Addendum 15 – UN Regulation No. 16

Revision 9 - Amendment 1

Supplement 1 to the 07 series of amendments – Date of entry into force: 10 February 2018

Uniform provisions concerning the approval of:

Figure 2

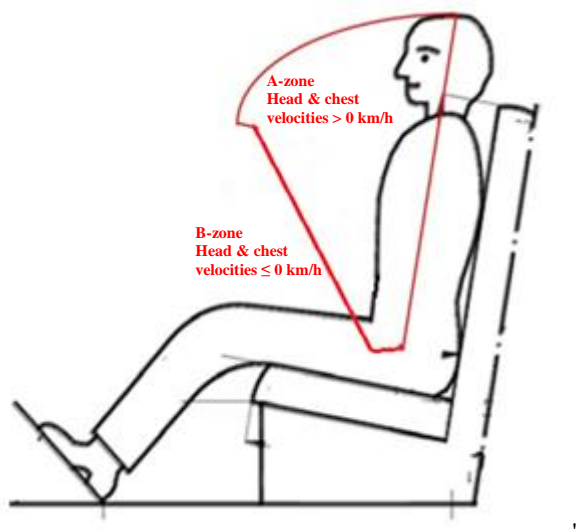
Insert a new item 12.1., to read:

- "12.1. In case a restraint system has been granted/extended approval, those can be used for particular types of vehicles compatible with the following dimensional conditions: no interior part in a quoted A-zone as shown below (Figure 2):

"Figure 1

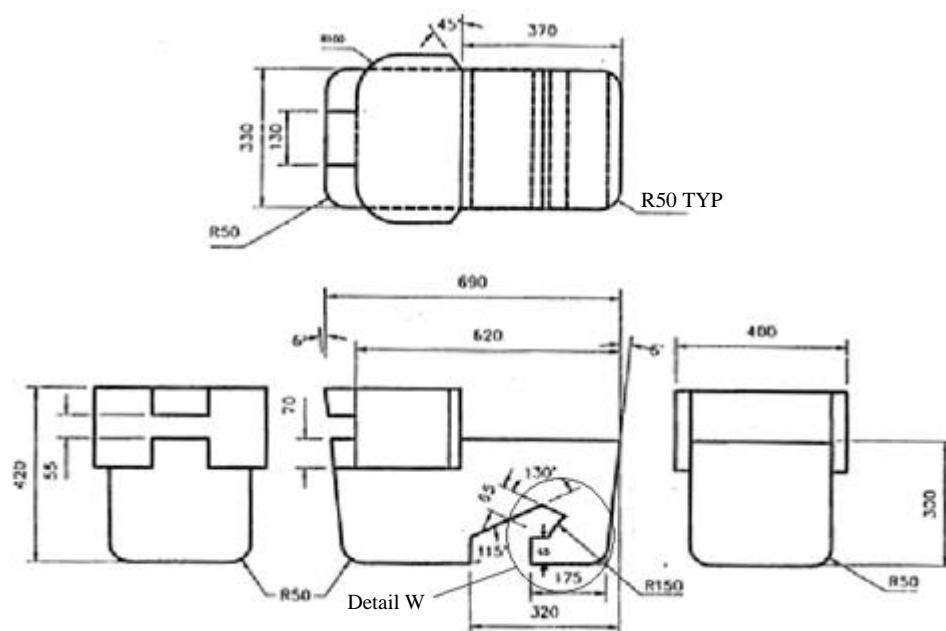
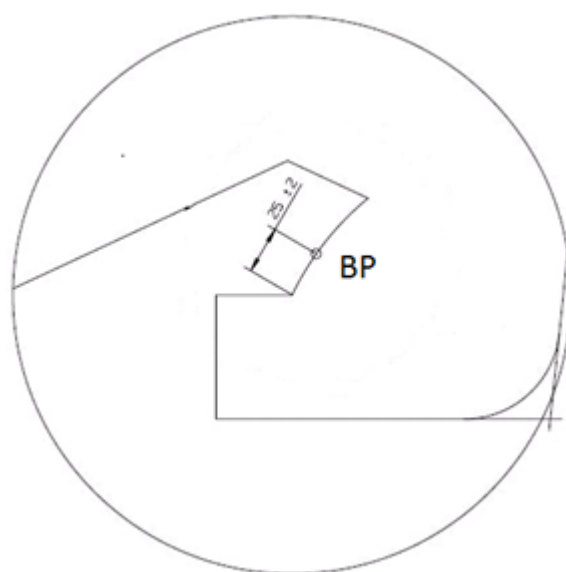
"3.2. The lap portion of the belt shall touch the fixture on both sides at the rear of the lap belt path (see Figure 3). The seat belt webbing shall always cover the points BP on the left and right ends of the curved edge; the exact position of point BP on the curved edge is indicated in detail W of Figure 1."

Figures 1 to 3, amend to read:

Figure 7

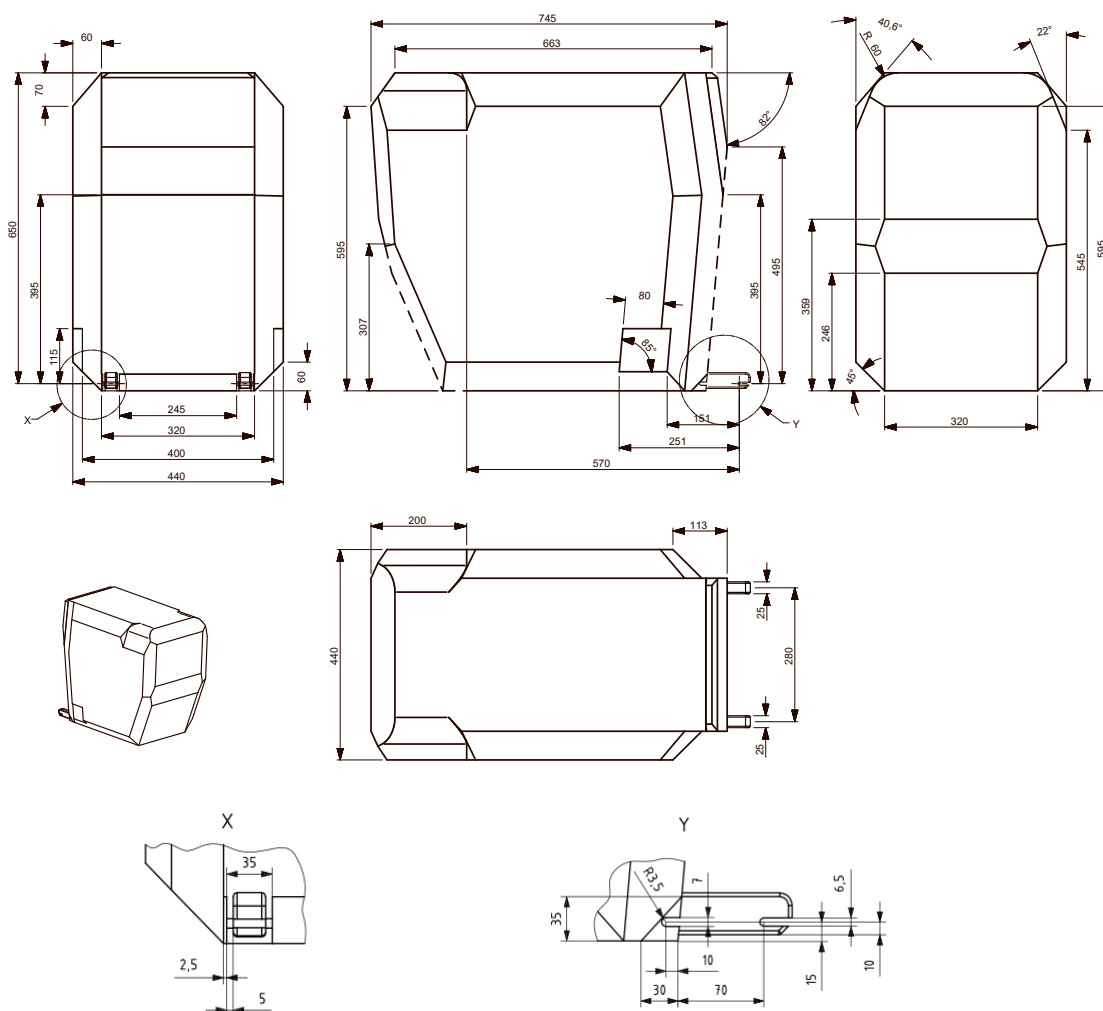
Appendix 2, insert a new paragraph 4.7. and a new Figure 7 to read:

"4.7. Rearward facing infant child restraint systems envelope ISO/R2X

Figure 8

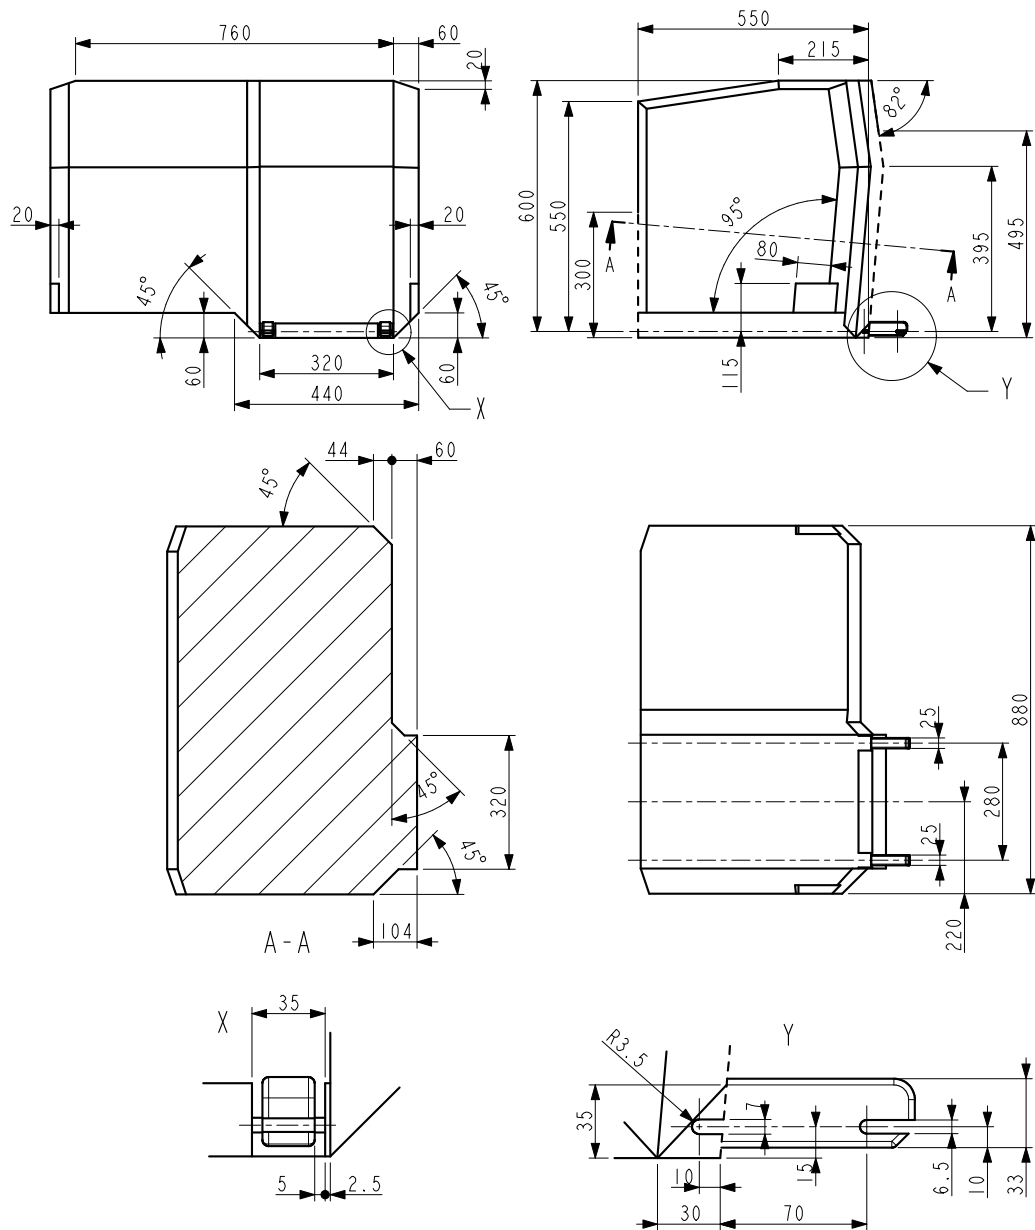
Appendix 2, paragraph 4.7 (former), renumber as paragraph 4.8. and amend to read:

"4.8. Lateral facing child restraint systems envelope

Figure 1
Positioning in Seat

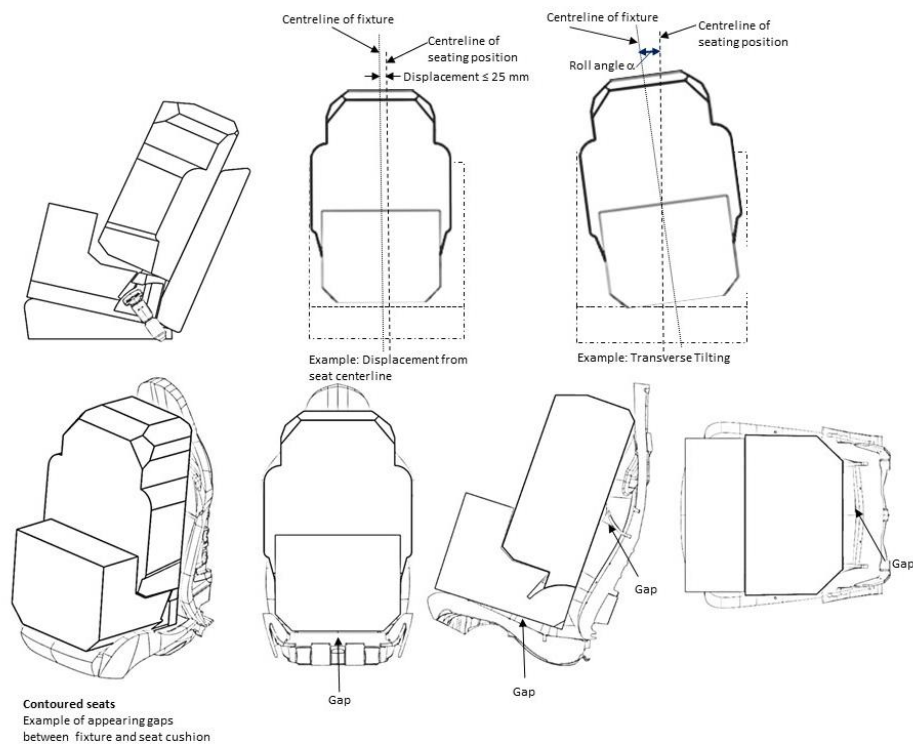
Insert a new Appendix 5 to read:

- 2.10. Ensure that the fixture is located with its centreline on the apparent centreline of the seating position ± 25 mm with its centreline parallel with the centreline of the vehicle seat. The roll angle α (see Figure 1) shall be within $0^\circ \pm 5^\circ$

3. Requirements
 - 3.1. It shall be possible to secure the fixture in the seating position using the 3-point seat belt and to buckle up the seat belt.
 - 3.2. The roll angle α as shown in Figure 1 shall be equal to or less than 5° .

- 3.3. The base of the fixture shall be in contact with the seat cushion, and the back face of the fixture shall be in contact with the seat back or head restraint. Full contact with the seat is not necessary, "gaps" due to the vehicle seats contours are permitted as shown by the arrows in Figure 1. The booster seat envelope is equipped with an adjustable backrest. Compatibility with the vehicle seating position shall be achieved in at least one position of the backrest range shown in Figure 2 or Figure 3.

Figure 2

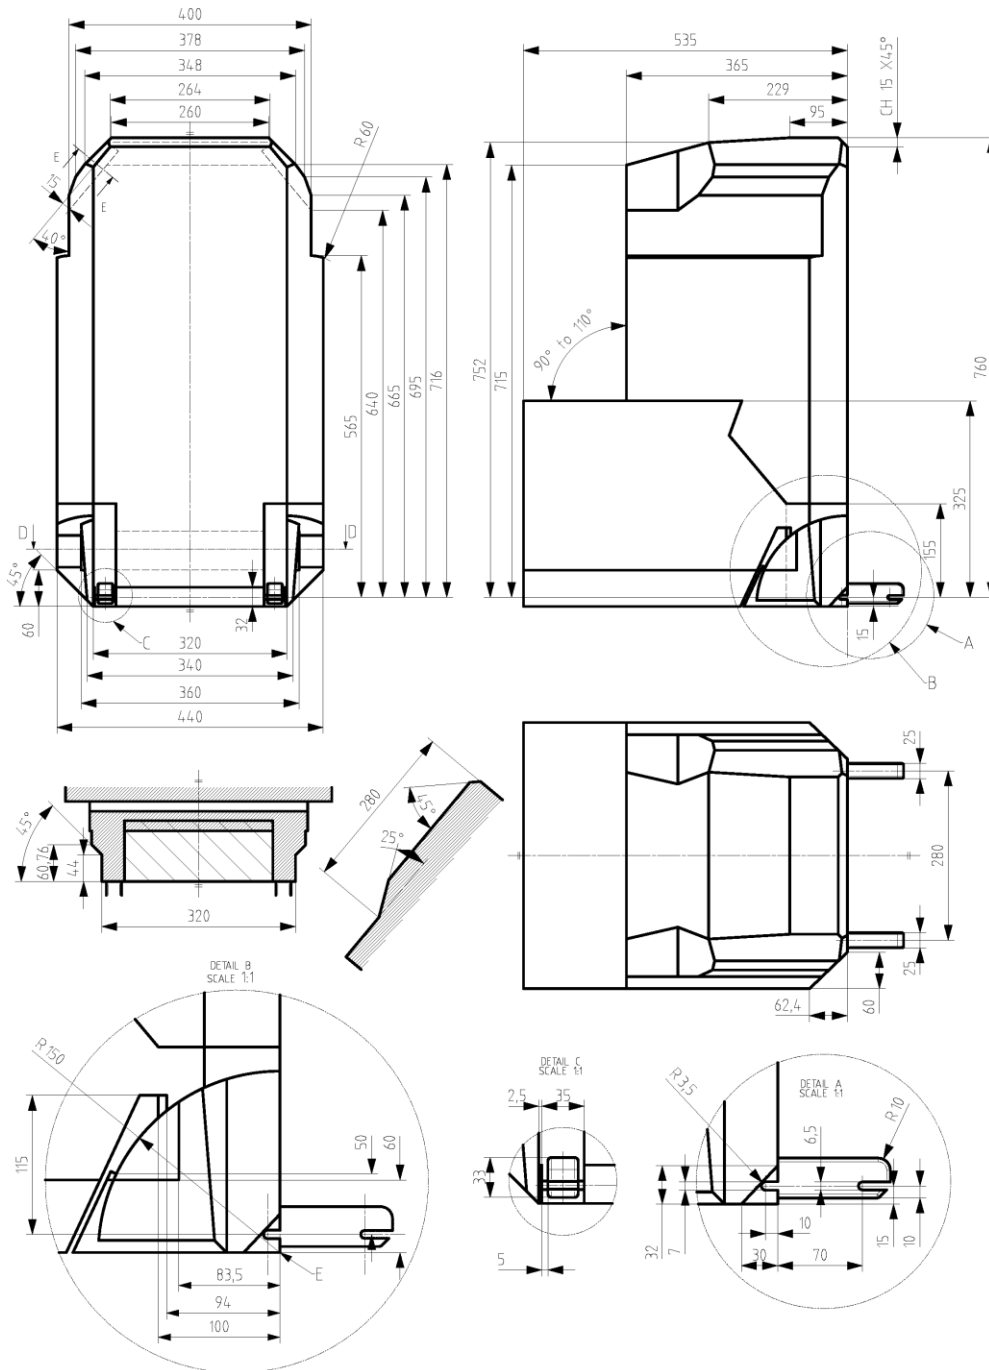
4. Booster seat child restraint system fixtures:
 - (a) ISO/B2: Booster seat, reduced width 440 mm (Figure 2)
 - (b) ISO/B3: booster seat, full width 520 mm (Figure 3)
